Product Alert Notification (PAN)

Subject: Product Marking Change

DA16600MOD-AAC

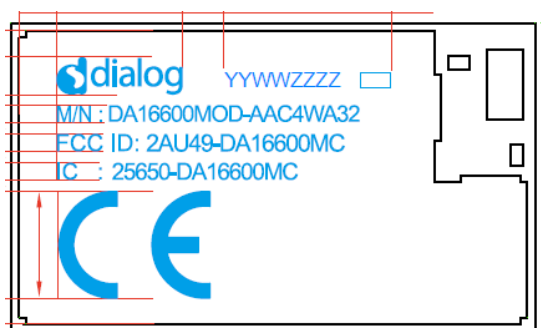
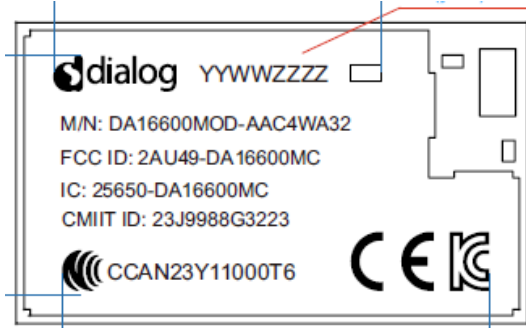
Renesas is changing the log on the shield-can because of NCC and SRRC certification.
